Figure 2.1a
Infrastructure Design Review
- Turbine 01

Bhlaraidh Wind Farm Extension
S36C Varied Development

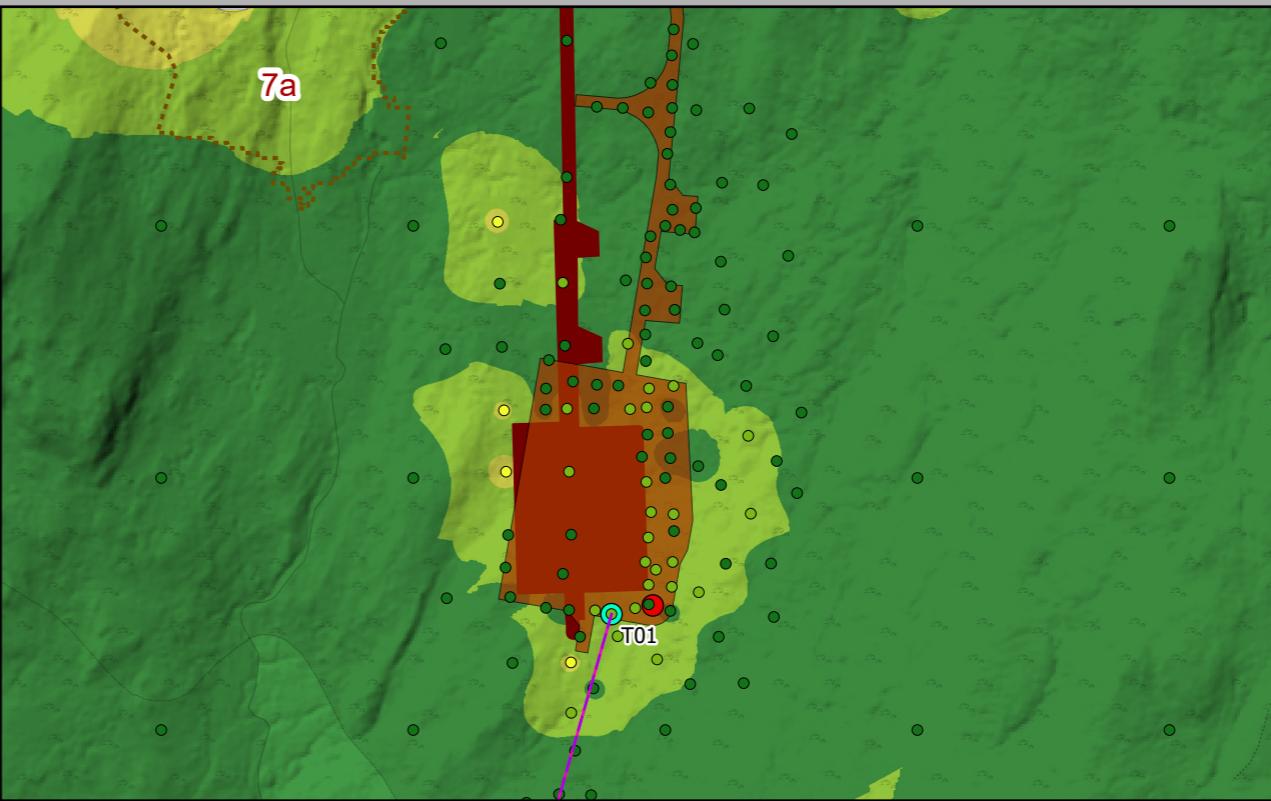
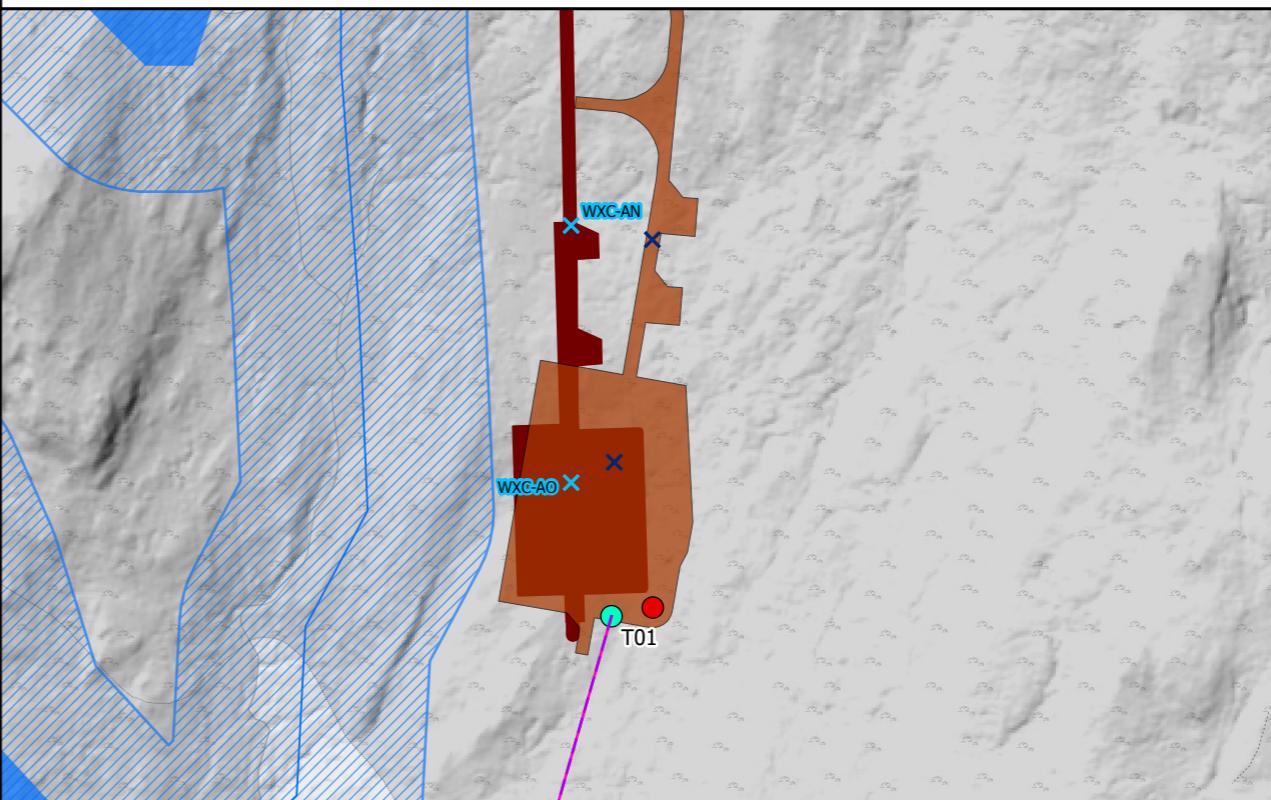
T01: Reason for Moving: The move was necessary to accommodate an unloaded turning head, allowing turbine delivery vehicles to exit the hardstand after delivery.

Engineering: The hardstand has been slightly rotated clockwise to achieve a better balance of cut-fill and to keep the new turning head at suitable distance from the 50m Watercourse Buffer

Geology Impacts: The larger hardstand and new turning head required the platform to be rotated clockwise. All proposed infrastructure within current consented 50m micrositing buffers. All proposed infrastructure in similar peat depths and slide risk areas as the consented location.

Ecology Impacts: Rotating the platform ensures that the constructed infrastructure remains within the same NVC Survey habitat type (M15c) as the consented infrastructure.

Hydrology Impacts: The platform's rotation and new turning head move the construction away from the 50m water buffer. If the original alignment were used, the turning head would encroach into the buffer. Placing the turning head east of the track would require significant cutting. As per the current consented location, a water course crossing is required on the track at the entrance to the hardstand.
